Newmar Corporation Warranty Department

Technical Service Bulletin			
Date Issued	Model Year(s) Affected	Model(s) Affected	TSB #
12/29/2010	2002 - 2010		379
Brand		Type	
All <input type="checkbox"/> Torry Pine <input checked="" type="checkbox"/> Cypress <input checked="" type="checkbox"/> Kountry Aire <input checked="" type="checkbox"/> Mountain Aire <input checked="" type="checkbox"/> Essex <input checked="" type="checkbox"/>		All <input type="checkbox"/> TT <input type="checkbox"/> FW <input checked="" type="checkbox"/> CA <input type="checkbox"/> DP <input checked="" type="checkbox"/> DB <input type="checkbox"/>	
<input type="checkbox"/> Air Conditioning & Heating <input type="checkbox"/> Appliances & Accessories <input type="checkbox"/> Cabinets & Furniture <input type="checkbox"/> Chassis Components <input type="checkbox"/> Construction Components		<input checked="" type="checkbox"/> Electrical Components <input type="checkbox"/> Exterior Components Interior Components <input type="checkbox"/> Plumbing & Bath Components <input type="checkbox"/> Windows, Awnings, Vents, & Doors

SAFETY RECALL NOTICE

How to identify recalled plug-in remote control receivers:

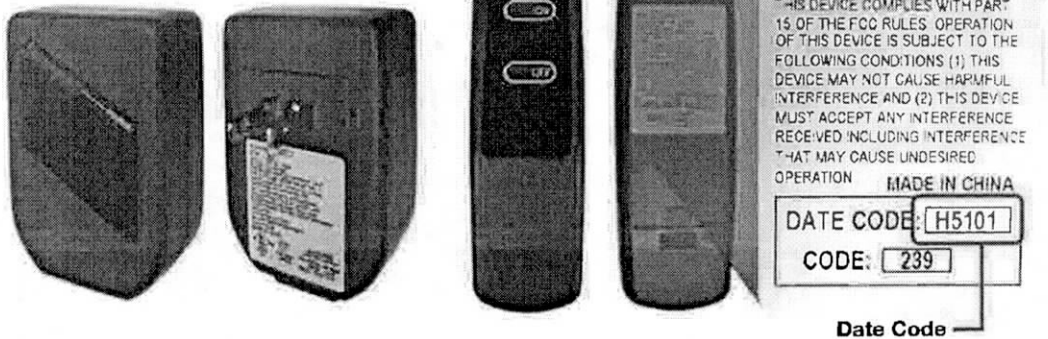
This style of recalled plug-in receivers have Model Numbers 47-1001 and 47-1010-R or DOC ID # 255K656-61-8367R

This style of recalled plug-in receiver has Model Number APT-1315

Dimplex North America will send you a new plug-in remote control kit, Model No. 47-1010-R* (note the asterisk *), at no charge for each kit listed on the form. On the new version, the name "Dimplex" appears on the front of the receiver in red.
